ADDENDUM NO. 3

San Antonio Water System

Project Name: LIFT STATIONS REHABILITATION DESIGN – PHASE 3

Project No.: 08-2504

NOTES	INITIALS	DATE
DESIGNED BY	CC	11/01/11
REVIEWED BY	AL	11/01/11
SCALE:	AS SHOWN	
SHEET NO.	E-13	
	129 OF 143

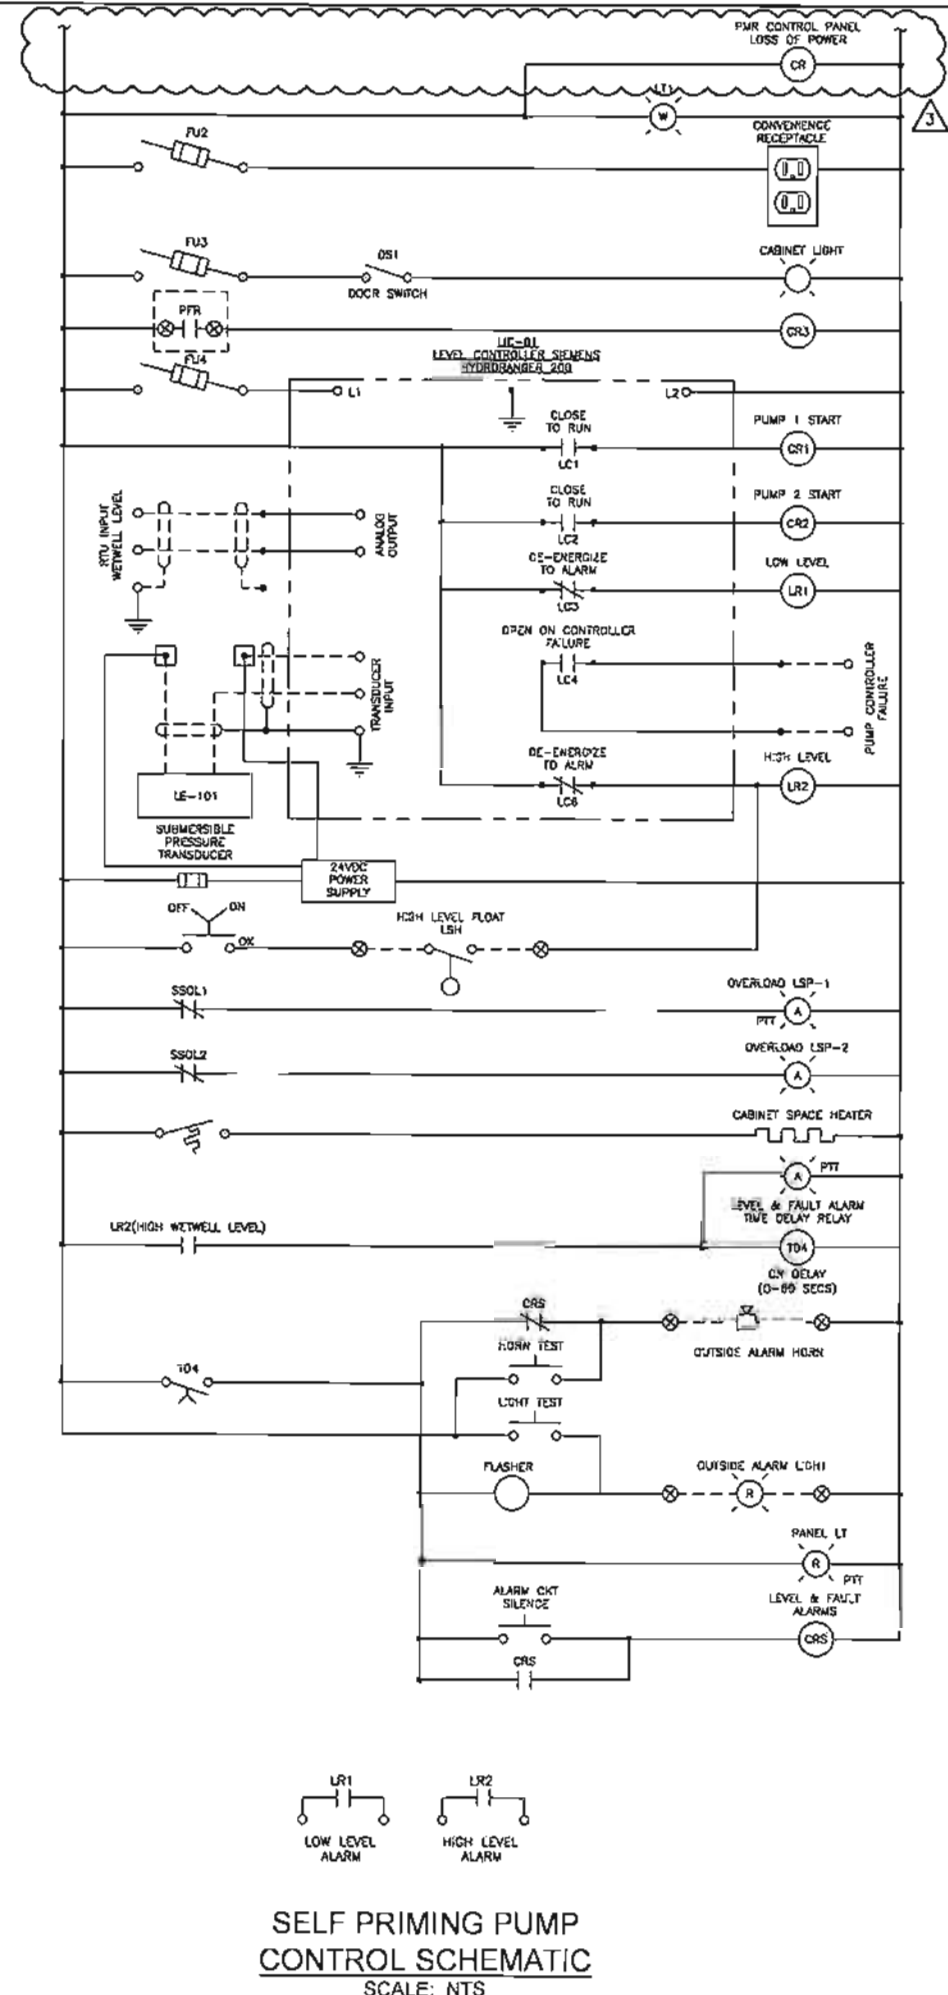
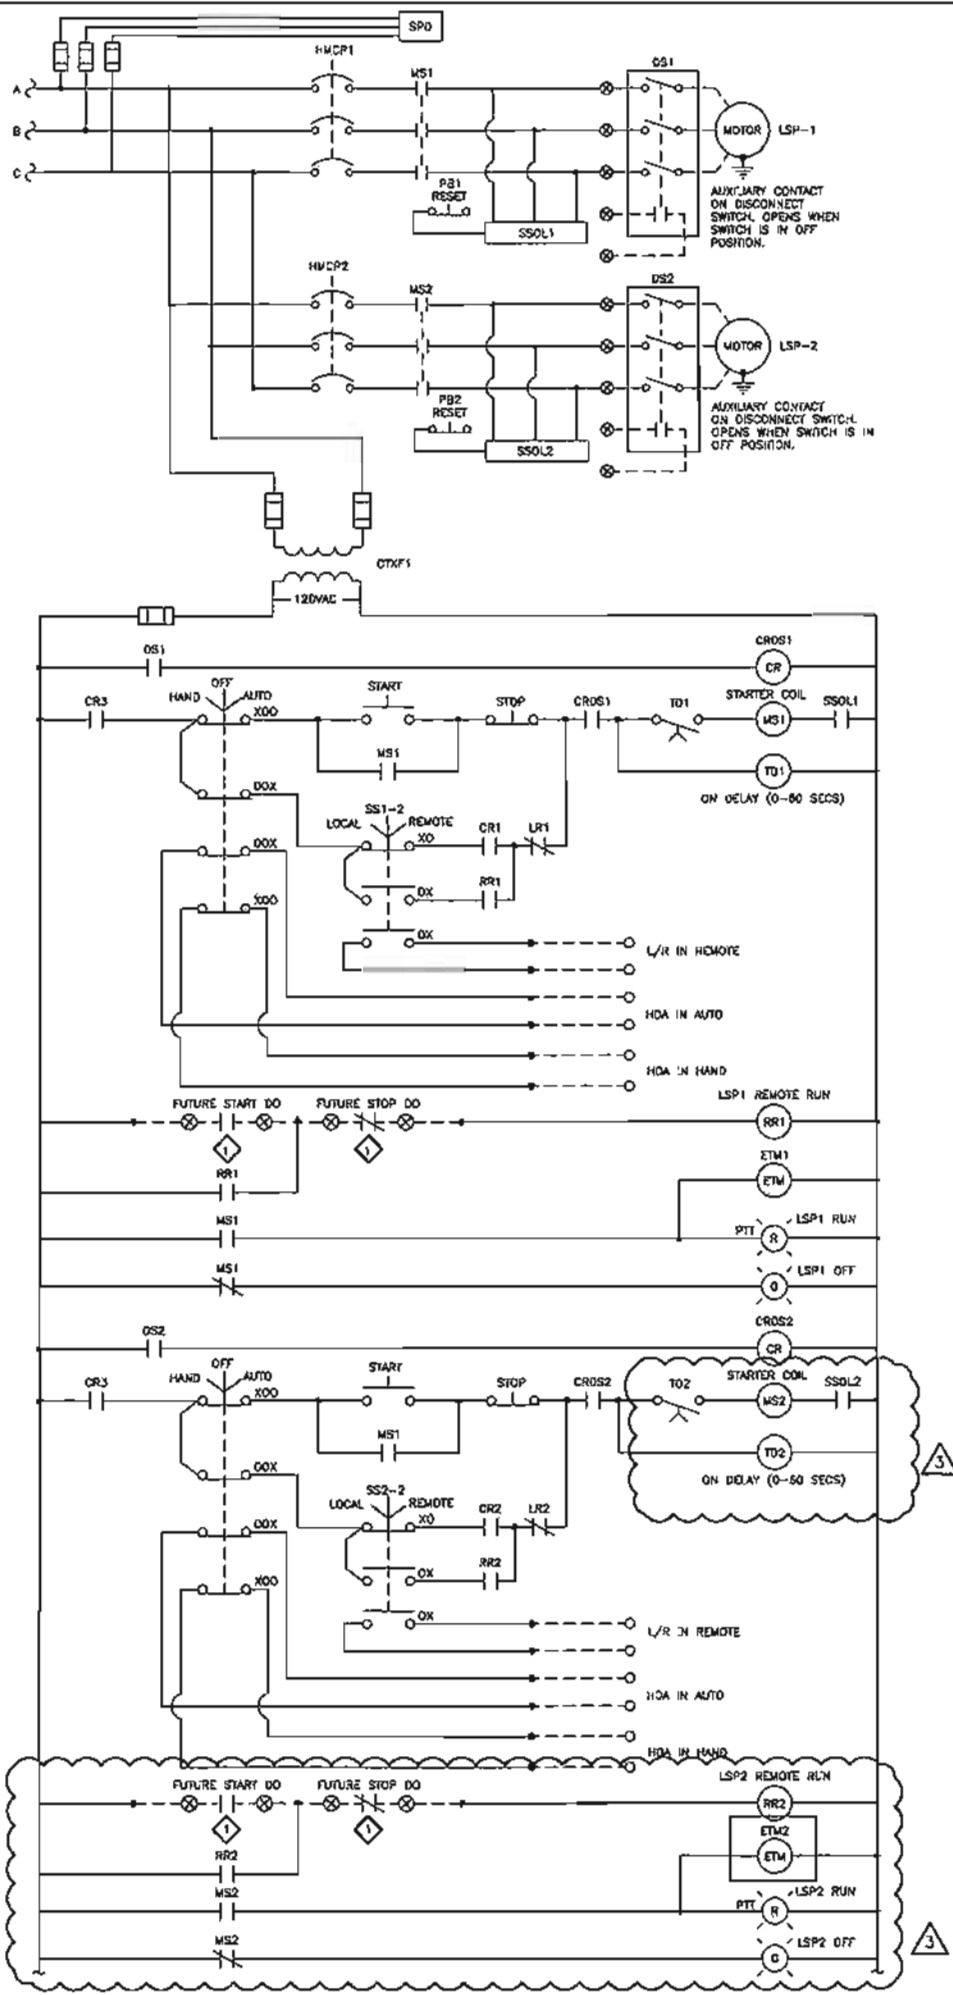
- Item 18: SHEET E-13 – SELF PRIMING PUMP CONTROL SCHEMATIC**
- a) REMOVE Sheet E-13, Sheet 129 of 143 and REPLACE with attached revised sheet dated November 1, 2011.

NOTES	INITIALS	DATE
DESIGNED BY	CC	10/07/11
REVIEWED BY	AL	10/07/11
SCALE:	AS SHOWN	
SHEET NO.	E-14	
	130 OF 143

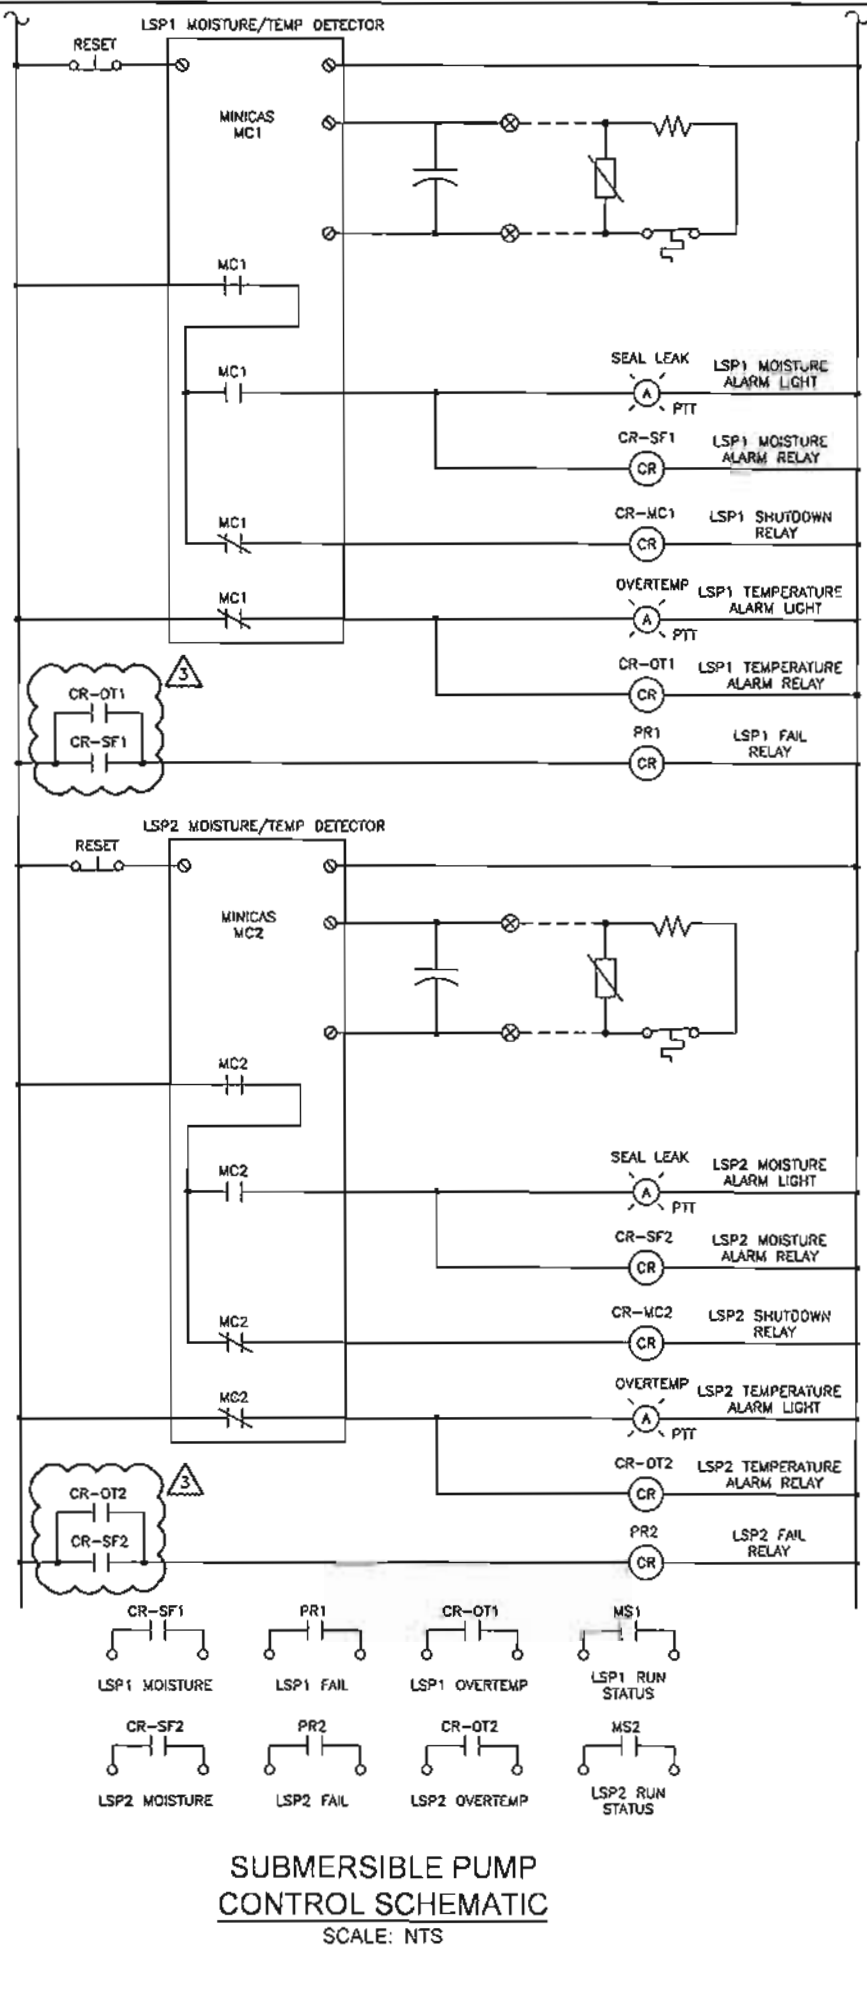
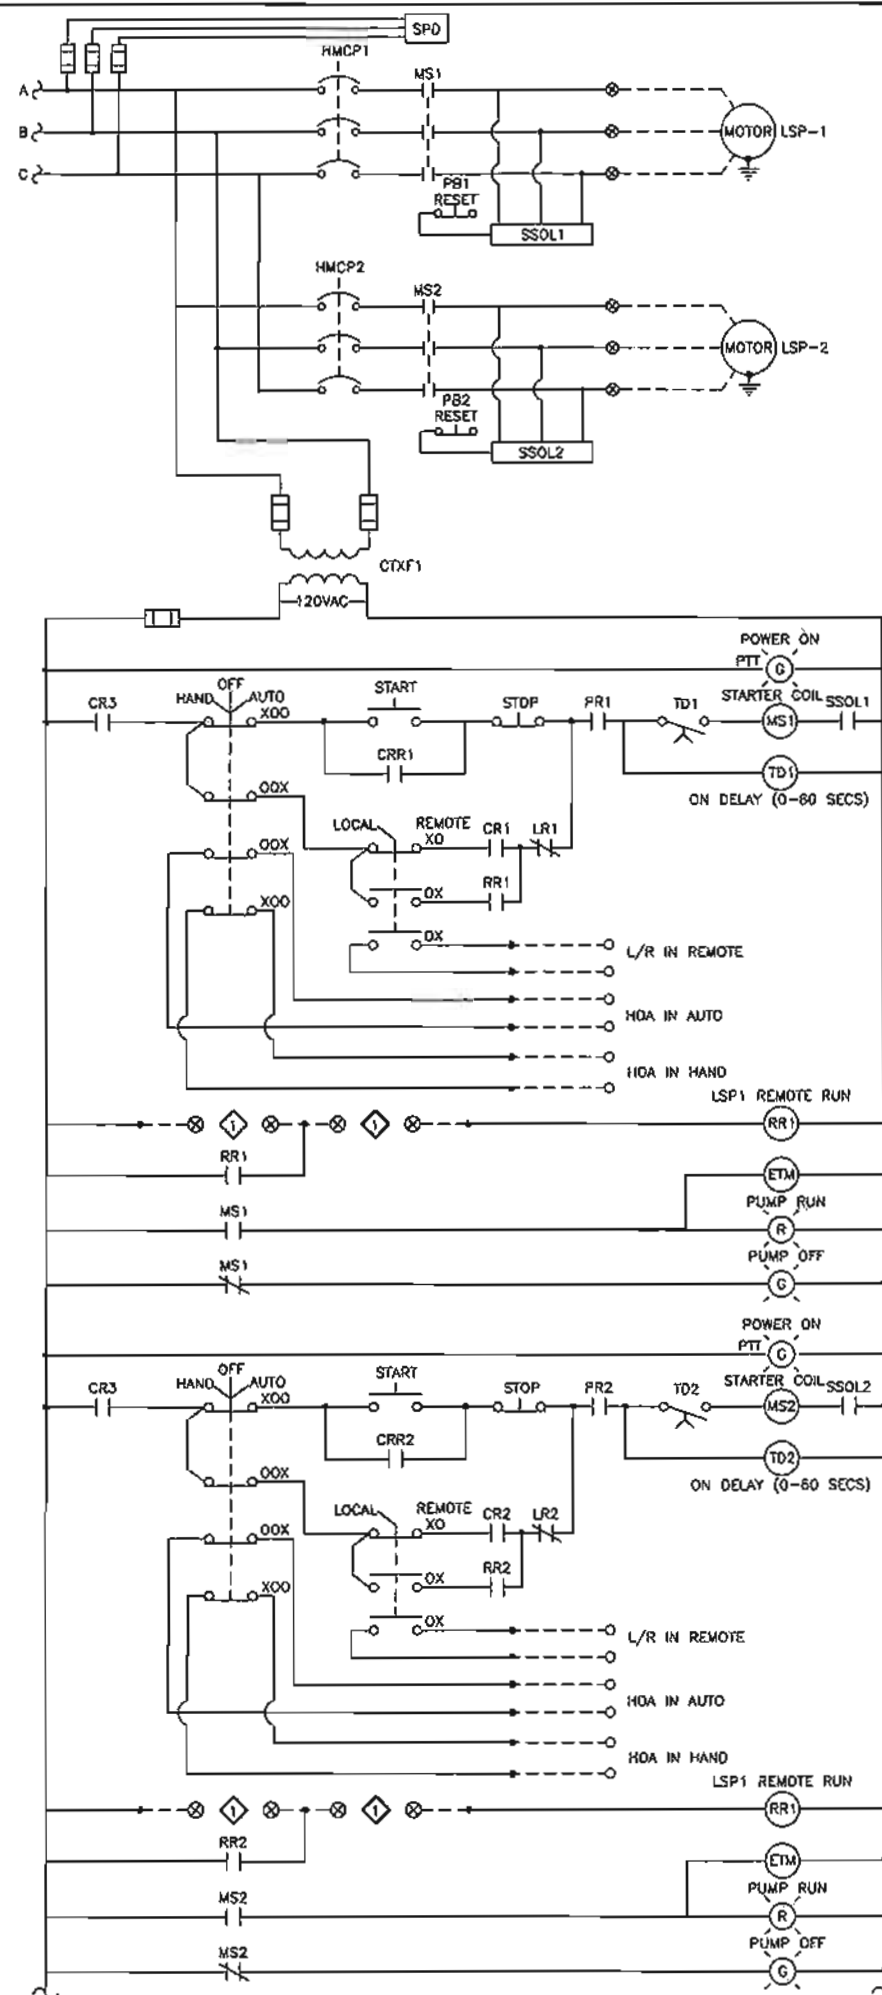
- Item 19: SHEET E-14 – SUBMERSIBLE PUMP CONTROL SCHEMATIC I**
- a) REMOVE Sheet E-14, Sheet 130 of 143 and REPLACE with attached revised sheet dated November 1, 2011.
